Product Name:	FlexLock Receptacle	
	10158558 - 28p / 36p	
Product Manager:	Jennifer.Zhang@amphenol-fci.com	
Subject:	Enter PCN distribution listing i.e., Global or name of customer(s)	
Distribution:	Affected customers	
Type of Change:	Notification of Change with Immediate Effectivity	
Change Description:	Add QR code on the bottom surface of connector	
Reason for Change:	To track contact spring dimension 0.20mm+/-0.05mm by QR code quality tracing	
Affected Parts:	See Affected parts.xls file	
Effective Date of Change:	August,01 2025	
Last Time Buy Date:	NA	
Earliest Disty Return Date:	NA	
Last Time Shipment Date	NA	
Datasheet Attached?	Yes	
Qual/Test Data Attached?	Yes	
Samples Availability Date:	01 August ,2025	
Available Alternatives?		
Questions?	<i>Contact your local ACS Representative, or Product Manager</i>	
	<i>Jennifer.Zhang@amphenol-fci.com / Product Manager</i>

10158558
QR CODE

FlexLock 10158558 28p/36p

QR code introduction For 10158558

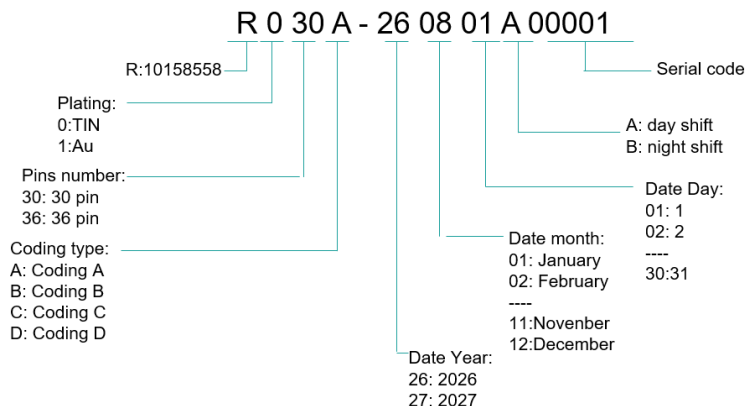
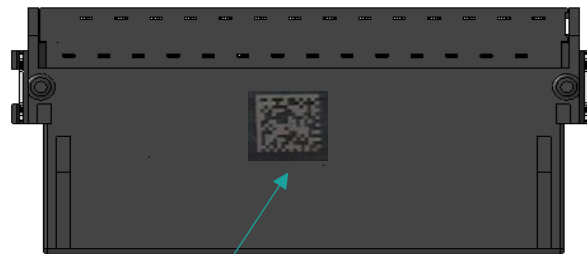
Before No "QR" CODE

在产品底面增加QR 码，便于追踪此产品的端子弹片gap 0.20+/-0.05 尺寸记录。

Add QR code on the bottom surface, and then we can track the contact spring dimension 0.20+/-0.05 of this connector.

After

With "QR" CODE

Reference as 10161735 on Auto Machine

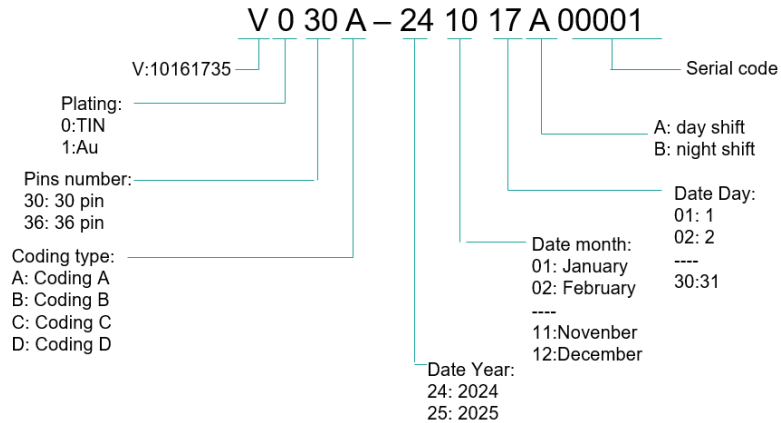
AG	AH	AI	AJ	AL
GAP32	GAP33	GAP34	GAP35	FeatureRstName
0.190	0.183	0.189	0.188	V036A-250506A00098

It is similar like 10161735.
